DESCRIPTIVE REPORT

Type of Survey Topographic Field No. Ph-26 (47) Office No. T-5592
LOCALITY
State Washington
General locality San Juan Island
Locality Kanaka Bay
1949-54
CHIEF OF PARTY C.W.Clark, Chief of Field Party H.A.Paton, Baltimore Photo. Office
LIDDADY & ADCUIVES

T-5592

Review Report Topographic Map T-5592 22 August 1955

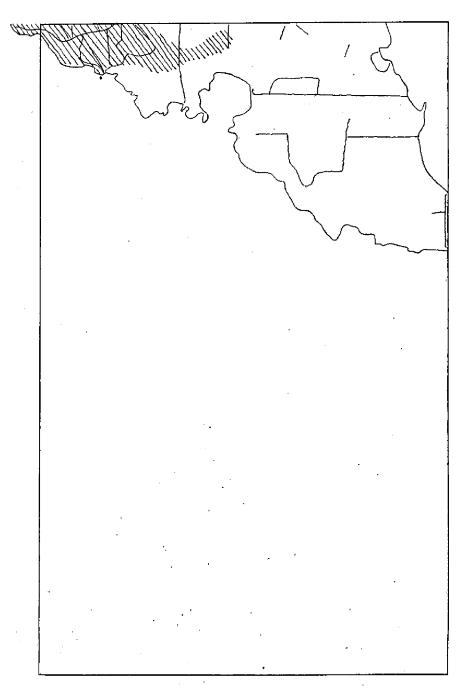
A weakness in horizontal position appeared in the vicinity of EDWARDS 2 1942 in the northwest corner of the sheet. The maximum error seemed about 35 feet. The trouble did not seem clear-cut and since the error did not exceed the 1.22 mm. maximum at this scale the matter was not pursued further. Detail in the immediate vicinity of the station checked reasonably, but positions carried into the station from a half mile distant by plane table would not check. This plane table traverse closed back on itself with a 10-foot closure and the azimuth from the vicinity of EDWARDS 2 to PILE POINT R M checked quite well, so it becomes difficult to say just what the trouble may be. EDWARDS 2 has been identified on Photo 1010 and an identification card is submitted with this report. Since the error seems not excessive I recommend no further investigation.

The contouring was generally good except in the northwest corner of the sheet where about a square mile was resketched. The error seemed about a half interval. It seemed unrelated to woodland. The extent of error into the sheet northward indicates a possible model warp, but there is too much woodland to the north to be certain. It is in the same area as the position difficulty. Possibly it is due to a vacuum failure in the camera.

Profile for vertical accuracy testing, 18 mis.

Resketched topography, about 1 sq. mi.
